Civil Case No. 08-2024-CV-00694

COY-036 Grade Approval Letter and Exhibit

This letter is in follow-up to grade approval request COY-036 that was submitted on April 4, 2023 for approximately 16.2392 acres in Section 25, T143N, R89W in Permit NACC-1302. The postmine land use of cropland and native rangeland as depicted on the SPGM respread map is consistent with Section 4.1.2 (Post-Mining Topography and Landuse Map) approved with Revision No. 11 and remains unchanged with pending Revision No. 12. Grade approval is granted based on a review of the submitted materials and a field inspection by PSC personnel. Furthermore, slopes exceeding 12% must be scarified to eliminate slippage prior to subsoil respread as stated in the Soils Handling Plan, Section 3.1.1.1, of the permit.

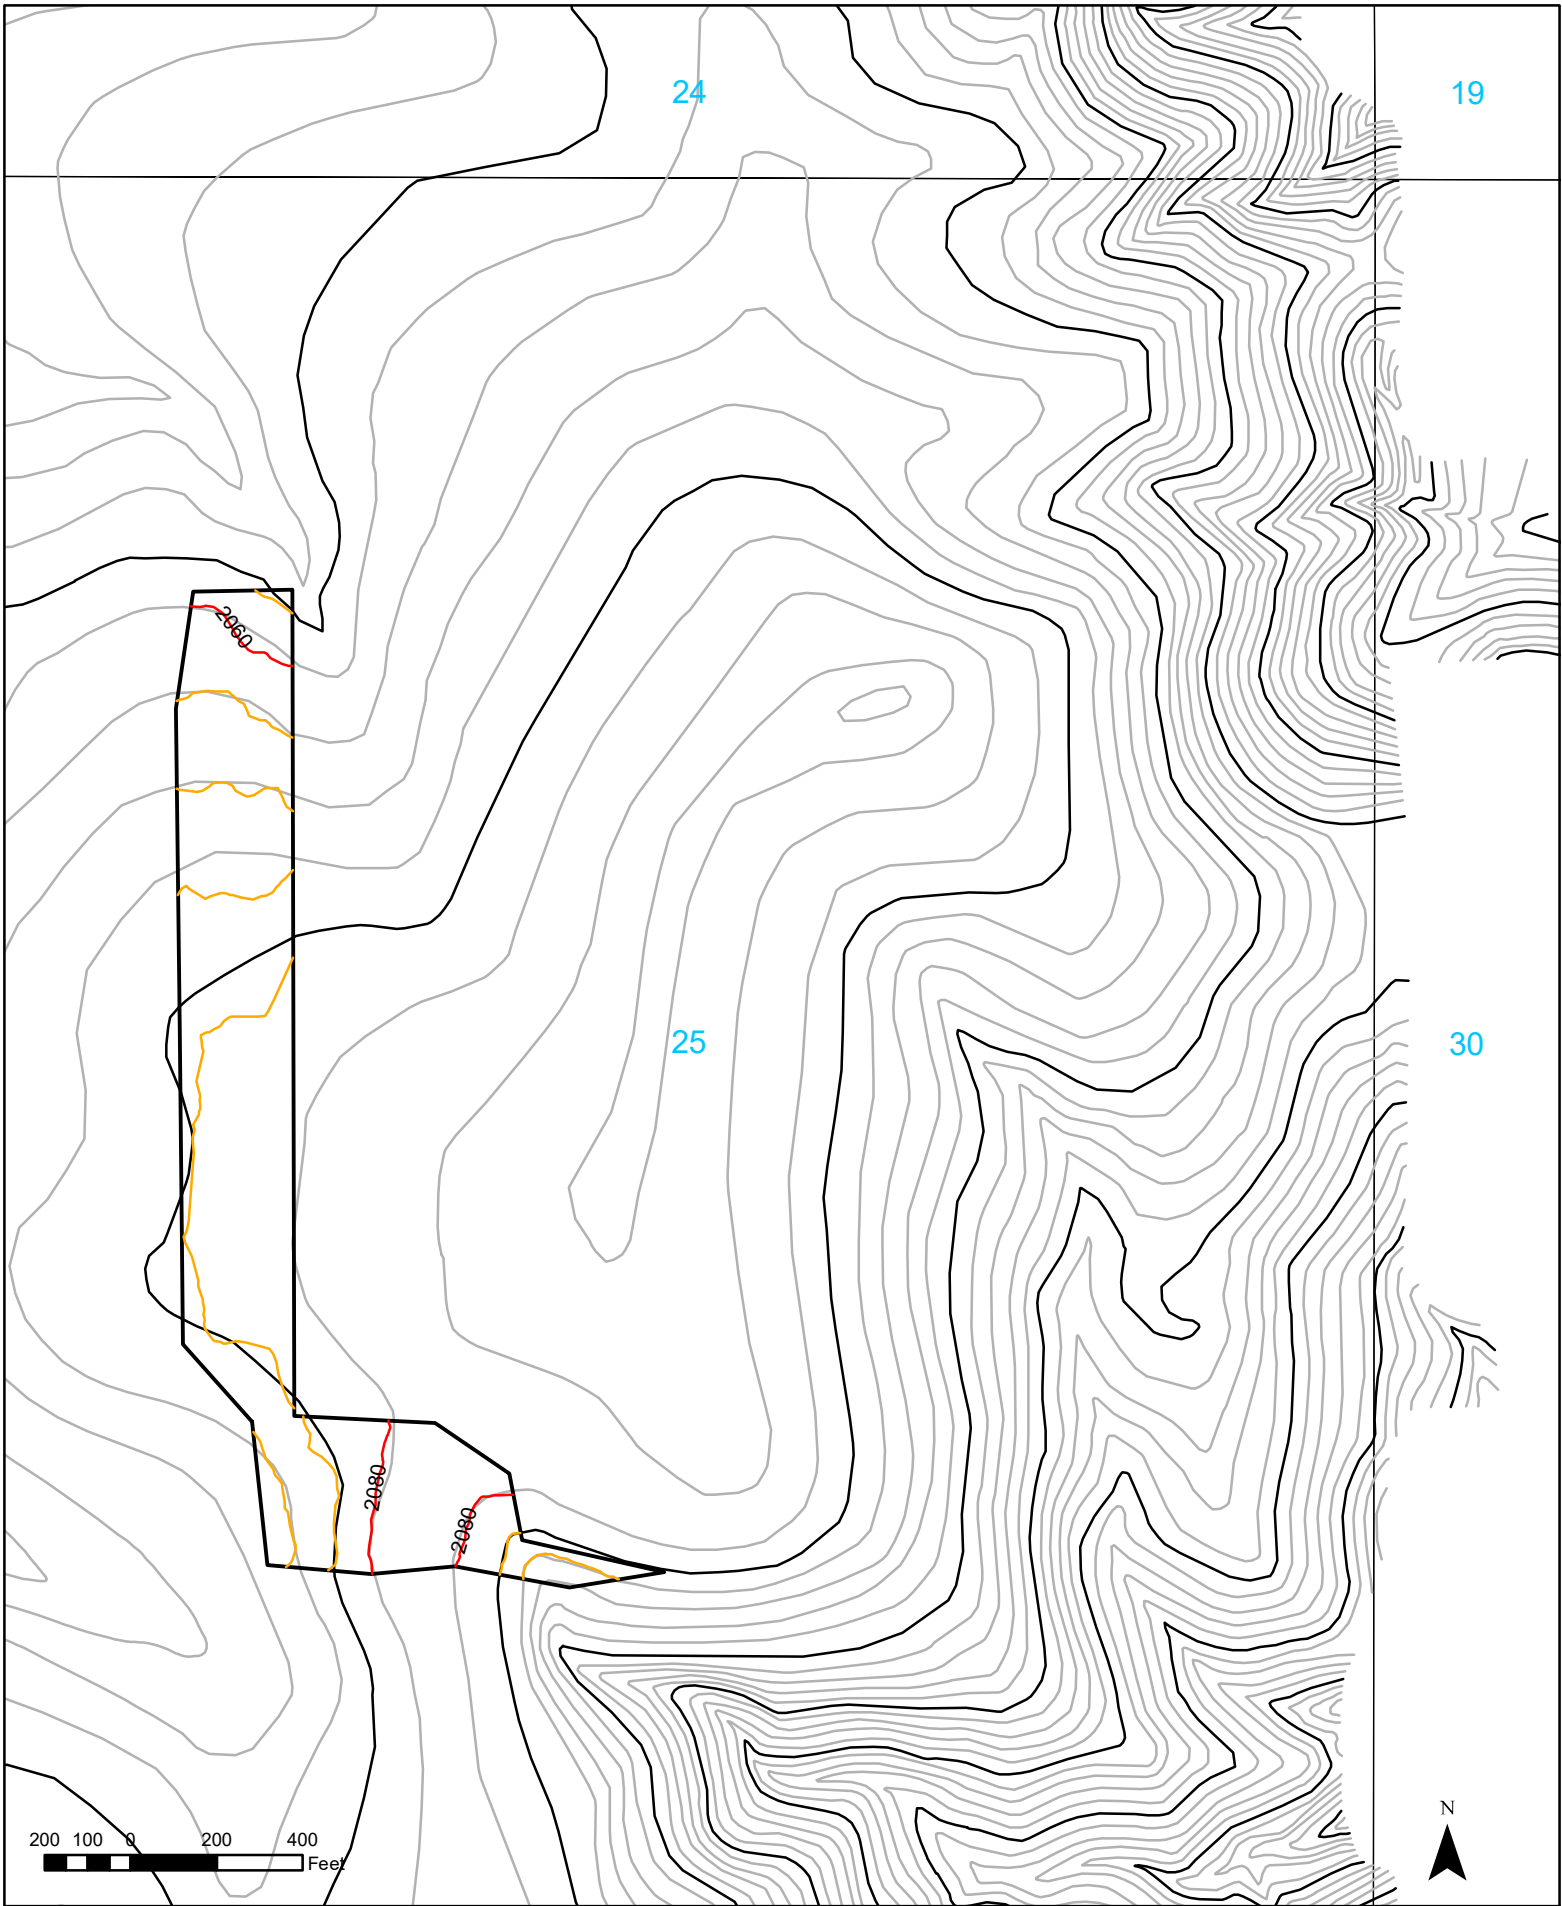
The proposed topsoil respread depth of 18.2 inches for Voigt ownership postmine cropland and 12.2 inches for Voigt ownership postmine native rangeland is approved. The total SPGM respread thickness of 24 inches, 36 inches, and 48 inches for the areas depicted on the submitted SPGM respread map is also approved. Blending will be necessary in areas having different total respread thicknesses, but without reducing the thickness of the area requiring the greater thickness and ensuring the proper drainage through the transition area.
